NUMBER: B392R1091-0

SERVICE BULLETIN

Ride: THUNDERBOLT

Subject: Load/Unload Safety Decal

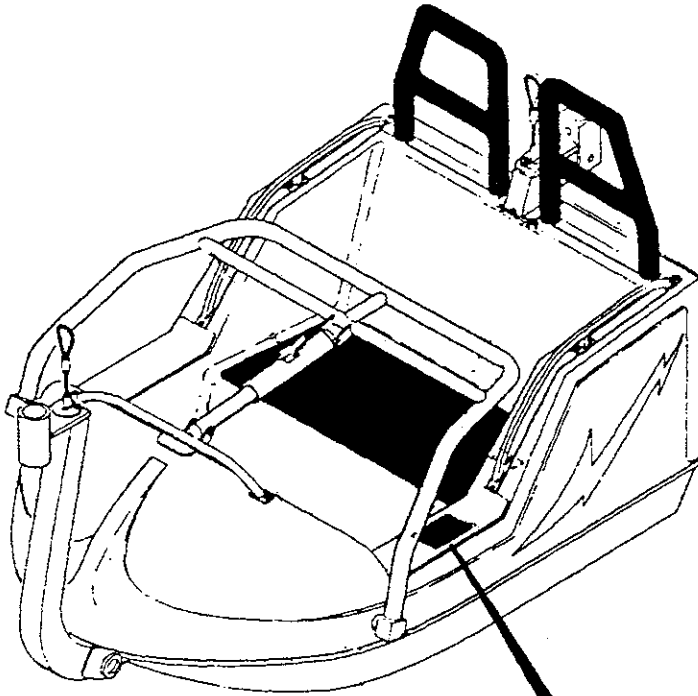
Chance Rides, Inc. has become aware that the vehicles on the THUNDERBOLT amusement ride may suddenly swing or shift while passengers are loading or unloading. This swing or shift is due to the passenger's weight on one side of the vehicle, placing the vehicle in an out-of-balance condition. ALL OPERATORS MUST VERBALLY CAUTION PERSONS OF POSSIBLE VEHICLE MOVEMENT AS THEY ENTER AND EXIT FROM THE VEHICLES.

A safety decal has been developed to help alert persons of possible vehicle movement as they enter and exit the vehicle. Chance Rides, Inc. requires all owner/operators of THUNDERBOLT rides to order and install one of these safety decals on each of the vehicles. A total of 18 decals are required for one ride. Order part number 22198506 and install as shown on this bulletin.

**VEHICLE MAY SWING
WHILE ENTERING
OR EXITING**
